**RE: Cibola Loop Multifamily  
Conceptual Grading Plan  
Engineer's Stamp Date: 11/06/2024  
Hydrology File: A13D011B**

Based upon the information provided in your submittal received 11/06/2024, the Conceptual Grading Plan is preliminarily approved for action by the Development Facilitation Team (DFT) on the Site Plan for a Building Permit.

**RE: Cibola Loop Multifamily  
Conceptual Grading Plan  
Engineer's Stamp Date: No Stamp Date  
Hydrology File: A13D011B**

Based upon the information provided in your submittal received 07/31/2024, the Conceptual Grading Plan **is not** approved for action by the Development Facilitation Team (DFT) on Site Plan for Building Permit. The following comments need to be addressed for approval of the above referenced project:

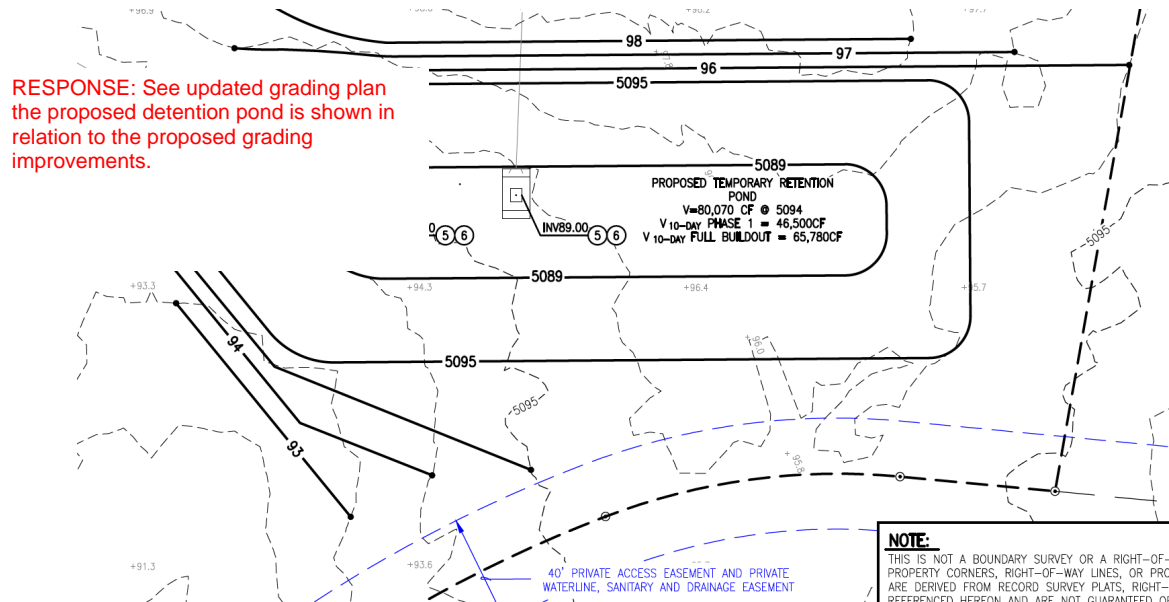
1. Please show the existing CoA Police Station that is on Tract B-9E-2-A which has been there since 2011. I do not think that the shown contours are current and reflect the benchmark change. This should be updated.

**RESPONSE:** It was determined that the previous contours were not current, a new topo survey was provided by a registered surveyor on 10/04/2024 that shows current contours around the perimeter of the police station.

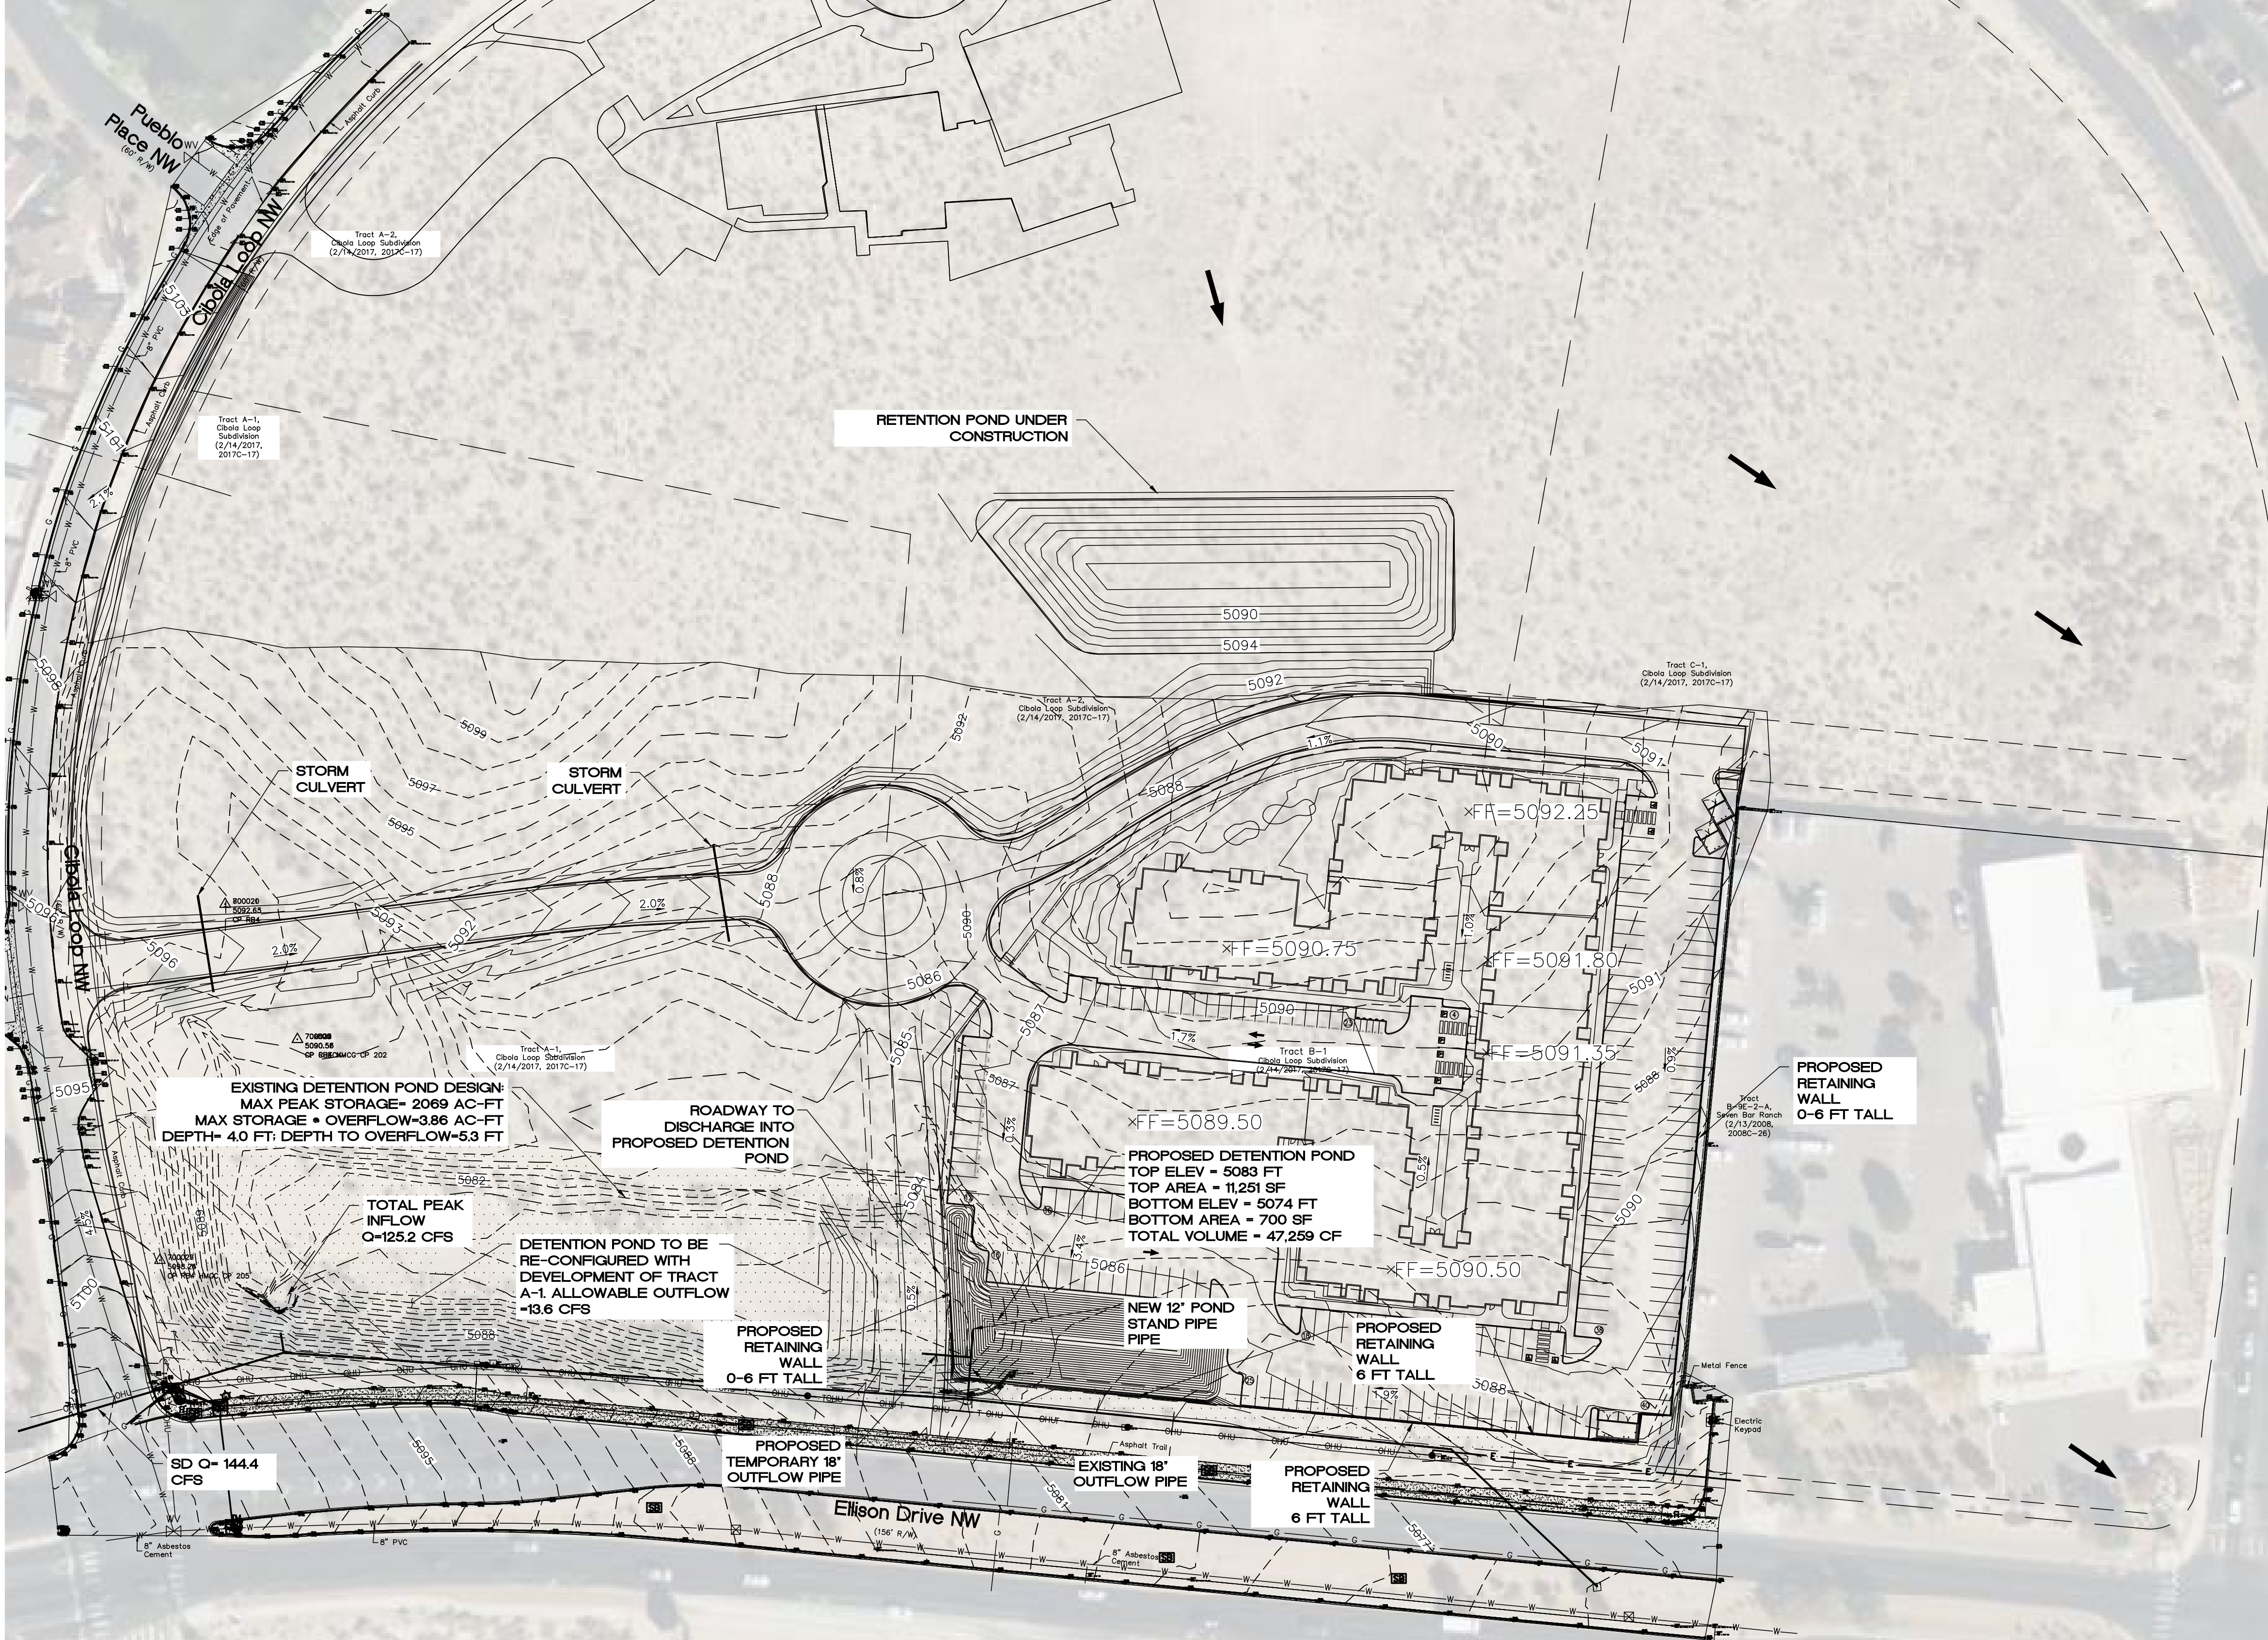
3. Please provide the Benchmark information (location, description and elevation) for the survey contour information provided.

4. Please provide the legal description of the property.

**RESPONSE:** Benchmark information provided on sheet GR-1 NAVD 88 ACS Monument "6\_A13"

**RESPONSE:** Legal description added to sheet GR-1.

**BENCHMARK - NAVD 88**  
ACS MONUMENT "6\_A13" HAVING AN ELEVATION OF 5103.431 FEET

**LEGAL DESCRIPTION:**  
TRACT B-1 BULK PLAT TRACTS A-1, A-2, B-1 & C-1 CIBOLA LOOP SUBDIVISION CONT 5.1785 AC

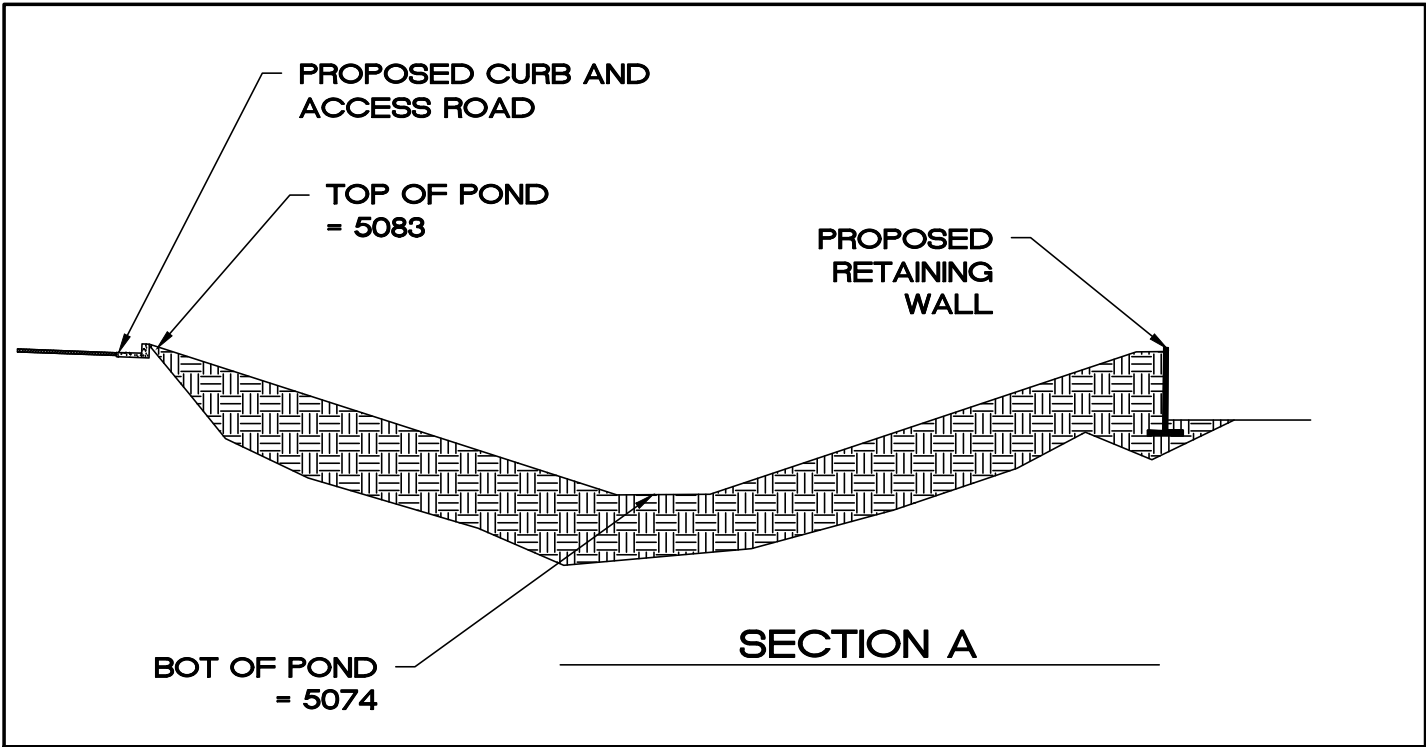
6. Please use the procedure for 40 acre and smaller basins as outlined in Development Process Manual (DPM) Article 6-2(a). Please provide both the existing conditions and proposed conditions for the 100 year-6 hour storm event. A statement "Refer to pervious Grading & Drainage Report HydroTrans A13D011B." is not acceptable.

10. Please provide the calculation for the required Stormwater Quality Pond per the DPM Article 6-12. To calculate the required SWQV, multiply the impervious area draining to the BMP by 0.42 inches for new development sites.

**RESPONSE:** See attached GR-2 and GR-3 (existing and proposed basin maps) the method of analysis used was ahymo and those calculations are attached.

**RESPONSE:** See sheet GR-3 storm water quality calculations table.

Total Impervious Area =	Retainage depth = 0.42" Per DPM	Area in "Treatment D"	0.0350	FT
Retention Volume =		0.035 x area D	CF	
Area D (4.678) =		203,773	SF	
Volume Required =		7,132.06	CF	
Volume Provided =		20,629.00	CF
